APPLICATION NO.	FILING DATE	FIRST NAMED INVENTOR	ATTORNEY DOCKET NO.	CONFIRMATION NO.
10/616,611	07/10/2003	Morris D. Stillabower	DP-308655 3336 EXAMINER	
22851	7590 07/07/2005			
DELPHI TECHNOLOGIES, INC.			SEMENENKO, YURIY	
M/C 480-410 PO BOX 505			ART UNIT	PAPER NUMBER
TROY, MI	48007		2841	
			DATE MAILED: 07/07/2005	5

Application No.	Applicant(s)				
Office Action Comments	10/616,611	STILLABOWER, MORRIS D.				
Office Action Summary	Examiner	Art Unit				
	Yuriy Semenenko	2841				
The MAILING DATE of this communication appears on the cover sheet with the correspondence address Period for Reply						
A SHORTENED STATUTORY PERIOD FOR REPLY IS SET TO EXPIRE 3 MONTH(S) FROM THE MAILING DATE OF THIS COMMUNICATION. - Extensions of time may be available under the provisions of 37 CFR 1.136(a). In no event, however, may a reply be timely filed after SIX (6) MONTHS from the mailing date of this communication. - If the period for reply specified above is less than thirty (30) days, a reply within the statutory minimum of thirty (30) days will be considered timely. - If NO period for reply is specified above, the maximum statutory period will apply and will expire SIX (6) MONTHS from the m

Fig. 4

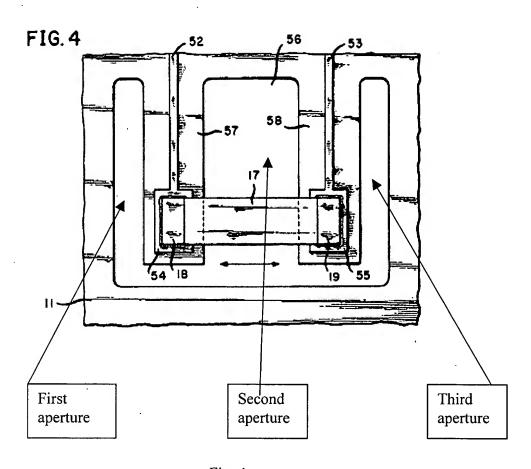
- 2.1.13. Regarding claim 19: Wannemacher discloses in Fig. 4 the circuit assembly according to claim 1, wherein the at least one aperture 56 comprises at least three apertures aligned in a row, first and second apertures of the at least three apertures (see Fig. 4 below) are adjacent and delineate a first compliant member 57 therebetween within the at the least one device 17 attachment region of the substrate 11, the second aperture and a third aperture (see Fig. 4 below) of the at least three apertures are adjacent and delineate a second compliant member 58 therebetween within the at the least one device attachment region of the substrate, and at least some of the pads 54 and 55 are located on the first and second compliant members.

- 2.1.14. Regarding claim 20: Wannemacher discloses in Fig. 4 the circuit assembly according to claim 19, wherein each of the at least three apertures is oblong-shaped in the plane of the substrate and in a direction transverse to a direction in which the first, second and third apertures are aligned. Although Wannemacher doesn't teach in Fig. 4 that each of the at least three apertures is discrete, Wannemacher does teach in Fig. 3 each of the at least three apertures 36, 37, 38 and 39 are discrete. At time the invention was made, it was well know to use discrete apertures in the plane of the substrate.

- 2.1.16. Regarding claim 22: And further, Wannemacher discloses in Fig. 4 the circuit assembly according to claim 21, wherein the first and second compliant members are separated by the second aperture (see Fig. 4 above).
- 2.1.17. Regarding claim 23: And further, Wannemacher discloses in Fig. 4 the circuit assembly according to claim 22. Although Wannemacher doesn't teach in Fig. 4 the first, second and third apertures are substantially equal in shape and size, Wannemacher does teach in Fig. 3 each first, second and third apertures are substantially equal in shape and size. At time the invention was made, it was well know to use the first, second and third apertures are substantially equal in shape and size.

- 2.1.18. Regarding claim 24: And further, Wannemacher discloses in Fig. 4 (see above) the circuit assembly according to claim 22, wherein the first, second and third apertures are substantially equal in shape, the first and third apertures are substantially equal in size, and the second aperture is wider than the first and third apertures in a direction in which the first, second and third apertures are aligned.

2.5.2. Regarding claim 26: And further, Wannemacher discloses in Fig. 4 (see above) the circuit assembly according to claim 25, wherein the first and second apertures are substantially equal in shape and size, and the third aperture is wider than the first and second apertures in a direction in which the first, second and third apertures are aligned.
